LOUP POWER DISTRICT

May 11, 2011

Subject: Loup River Hydroelectric Project
SISR Meeting Comments
FERC Project No. 1256
Docket 1256-029

Attachment A

Water Temperature Relationships Between Sites

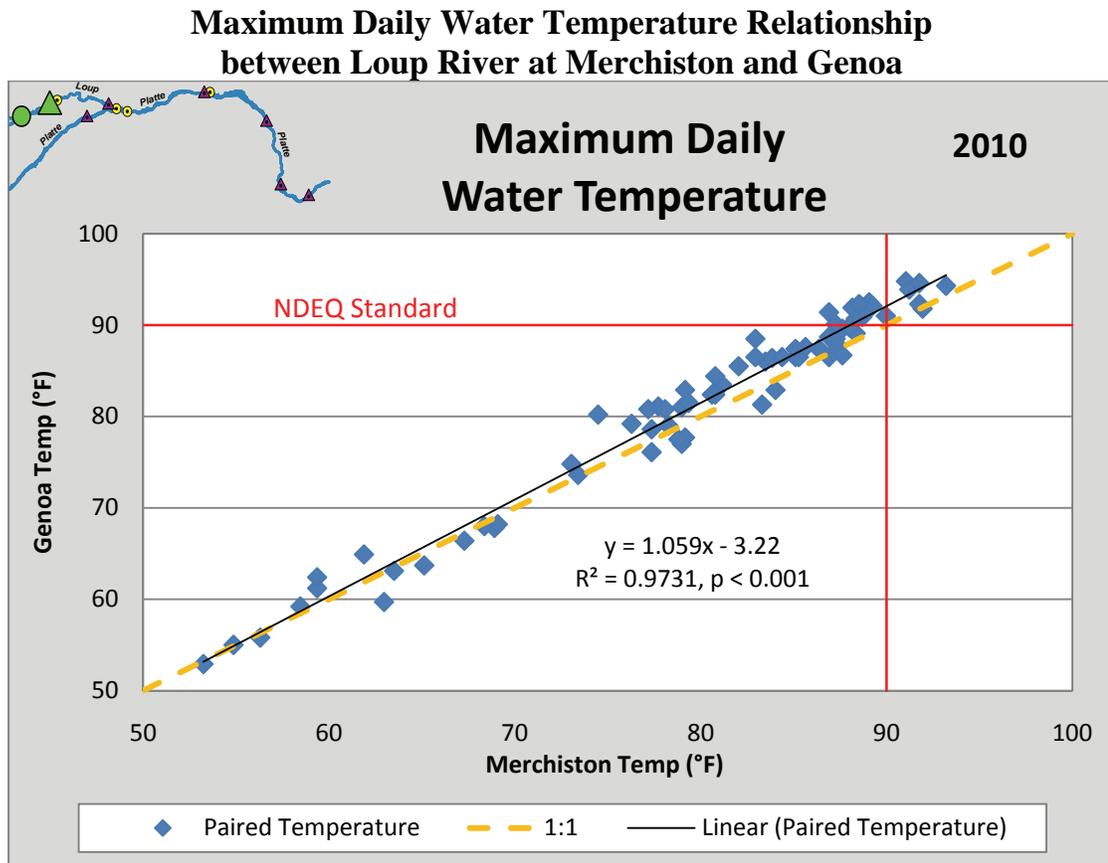
“In a preliminary analysis, NGPC examined the maximum daily water temperatures from the two sites for days exhibiting water temperatures greater than the 90 degree F water quality standard. A total of 13 dates from the 2010 sampling period (May – August) qualified under these constraints. Daily maximum water temperatures at the Genoa site ranged from 1.08 to 4.14 degrees F greater than those measured at Merchiston. In addition, the relationship between daily maximum temperatures differences for the two sites and flow (measured at Genoa) is a negative one. As the flow declines, the difference between daily maximum water temperatures at the two sites increases. This suggests that at these higher temperatures, water temperatures reach a higher maximum on a given day below the diversion than above it. The fact that there is a statistically significant relationship between the recorded water temperatures at the two stations confirms that water temperature is reacting in a similar manner to the changes in air temperature. The absolute difference in daily maximum water temperatures between the two sites at high temperatures and relatively low flows suggests a potential impact due to water diversion.”

The fact that there is a statistically significant relationship is important, but it is more important that the relationship is near 1:1, as shown in the following graph.

District records show that there were 15 total days that the daily maximum temperature at Genoa was greater than 90 degrees F. Of these 15 days, the difference between Merchiston temperature and Genoa temperature ranged from -0.14 to 4.5 with an average of 2.5. As shown in the graph below, on days with exceedances, the difference between the maximum daily water temperatures does not increase as flow decreases, in fact the difference is nearly constant as indicated by the slope of the regression line.
